### ADDENDUM No. 2

DATE ISSUED: October 29, 2018

#### RE: STORM DRAINAGE IMPROVEMENTS ON PECK/RICHARD ROAD (BID # PRD-027-110118)

SCALE N.T.S. APPROVED	CITY OF TORRINGTON Engineering Department
P.K. AUGUST 2018	SECTION 4.22
	UNDERDRAIN
	NON-PAVED AREAS

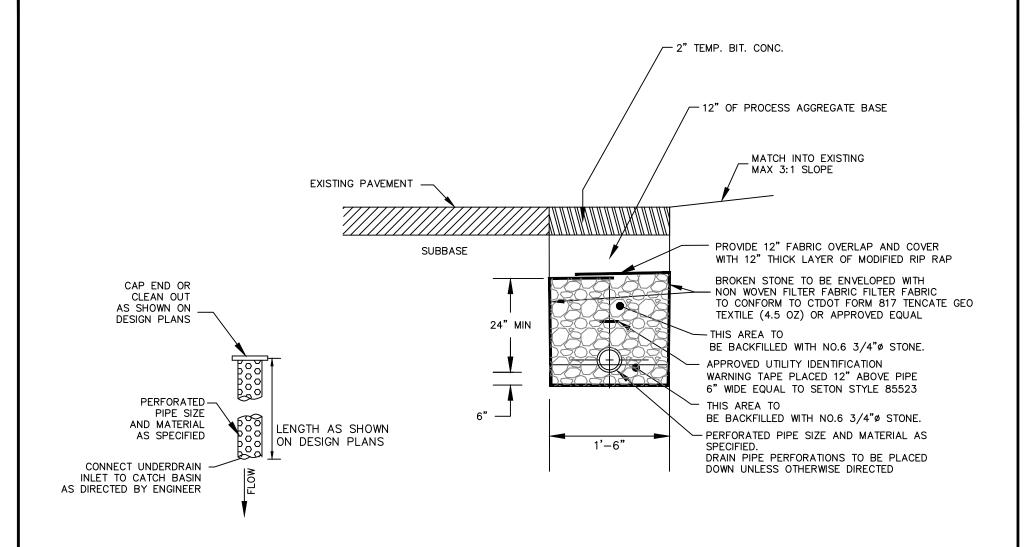
- 1. Add Detail Section 4.22 Underdrain in non-paved area
- 2. Add Detail Section 4.24 Underdrain in paved areas
- 3. Add Detail Section 4.4 Typical Storm Drainage Trench HDPE paved areas

- 1. PIPE TO BE N-12 ST (SOILTIGHT) IB (INTEGRAL BELL) DUAL WALL PERFORATED HDPE.
- 2. PIPE DIAMETER IS BASED ON LENGTH:
- 2.1. USE 4"ø (FOUR INCH) FOR UP TO 100'
- 2.2. USE 6"ø (SIX) FOR LENGTHS OVER 100'
- 2.3. USE 8"Ø OR LARGER AS DIRECTED
- 3. MINIMUM SLOPE 0.5%
- 4. CAP ENDS OF PIPE WITH APPROPRIATE FITTING END CAPS

SECTION 4.5

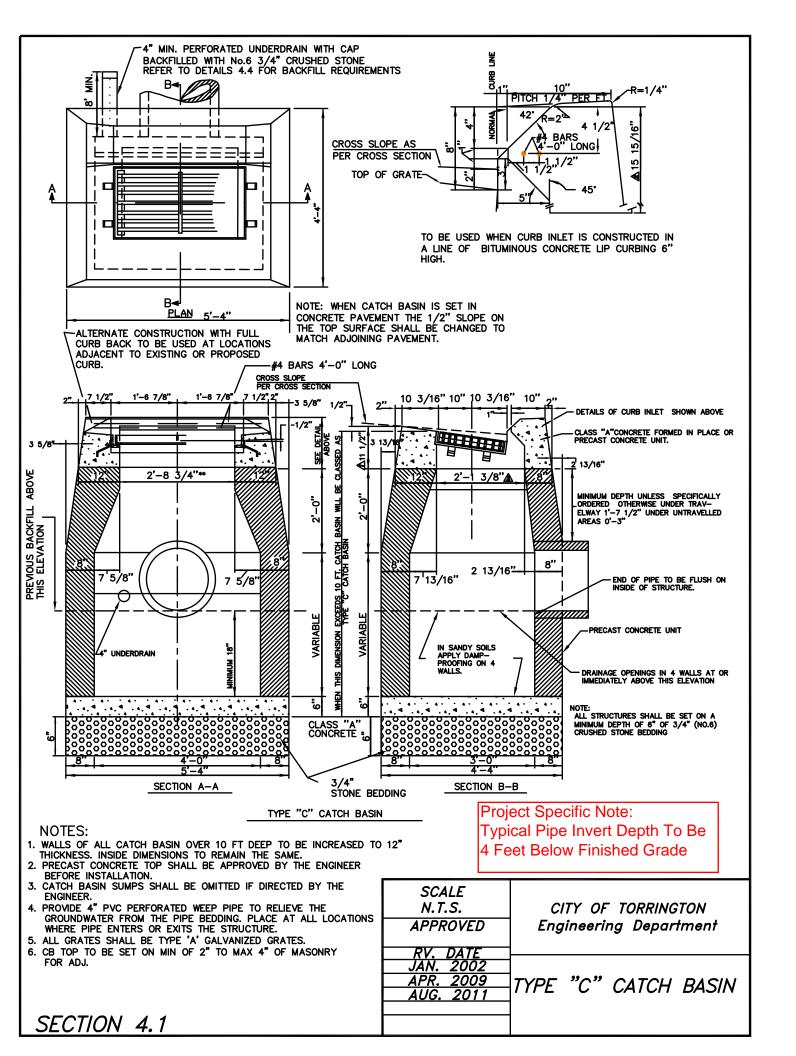
- 4. Add Detail Section 4.5 Typical Storm Drainage Trench HDPE non-paved areas
- 5. Add Detail Section 4.1 Type "C" Catch Basin
- 6. Replace Plan "Richard/Peck Rd Intersection Drainage Improvement Locations" dated 7/19/2018 with revised Plan dated 10/26/2018

Project Specific Note: Typical Pipe Invert Depth To Be 4 Feet Below Finished Grade
